CITY OF ELLENSBURG

Re: Bull Rd & Umptanum Rd – Bull Ranch – SEPA LP-21-00001

The following are the City Public Works SEPA comments for the proposed The Bull Ranch on the east side of Bull Rd at Umptanum Rd.

CITY OF ELLENSBURG PUBLIC WORKS DEPARTMENT UTILITY MAP REQUEST INFORMATION

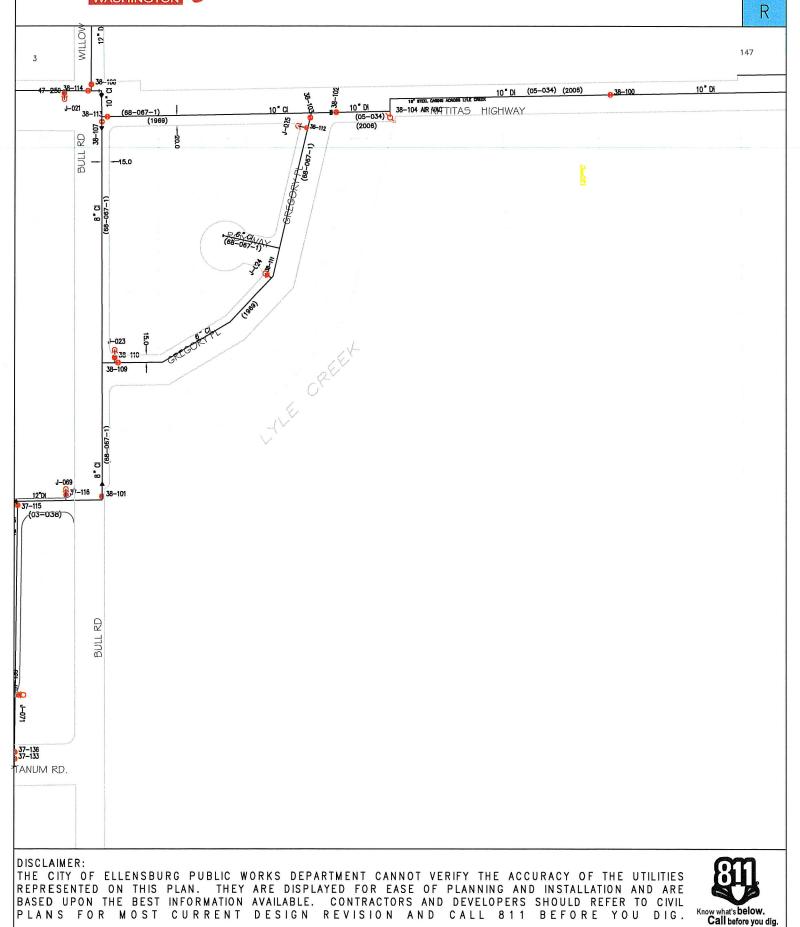
The water mains available to serve this development are a 10" Ductile Iron main that runs in Kittitas Highway and an 8" stub is being installed at Umptanum Rd extension as part of the City's Bull Rd project. The developer will need to build an 8" water main on all the proposed interior roads. Each lot will need a separate water service. The maximum number of lots that can be served by one water connection is 40 lots. The water system will need to be looped between Kittitas Hwy and Umptanum Rd. See attached utility map.

The sewer mains available to serve this development are a 10" PVC main in Kittitas Hwy and an 8" stub is being installed at Umptanum Rd extension as part of the City's Bull Rd project. The developer will need to install 8" sewer mains on the interior roads and side sewer stubs to each lot. See attached utility map.

There is no storm system available for a direct discharge. The existing road side ditchs will need to be conveyed across the frontages of the property. All storm facilities will need to be designed so they will not be inundated with ground water. Your engineer will need to verify groundwater during peak irrigation season to confirm the project will not be effected by it. See attached utility map.
